Subject: AP1000 Response to Request for Additional Information (SRP3.9.5)

AP1000 TECHNICAL REPORT REVIEW

RAI Response Number: RAI-SRP3.9.5-EMB1-03
Revision: 1

Figure 1 – Flow Skirt Isometric View

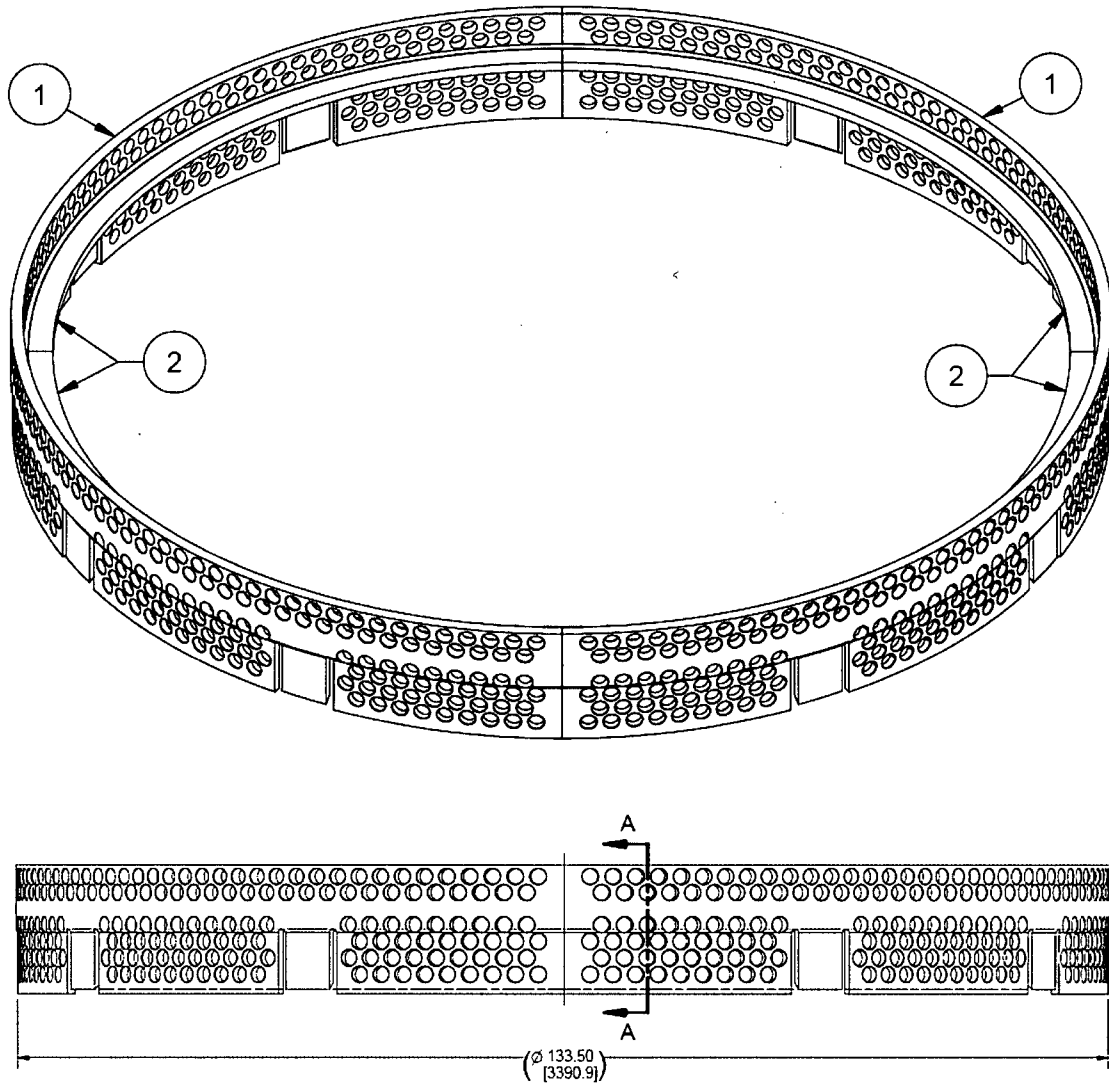
DCD Fig. 3.9-8 illustrates the flow skirt as a solid beam-like structure which is not representative of either its function or its description. Further clarification of Fig. 3.9-8, or additional figure details, should be provided to facilitate understanding of the form and function of this newly added component.

The flow skirt is a perforated cylindrical structure with a horizontal stiffening flange that is supported by eight lugs inside the reactor vessel lower head. Please see the attached Figures 1 and 2, which illustrate the flow skirt.
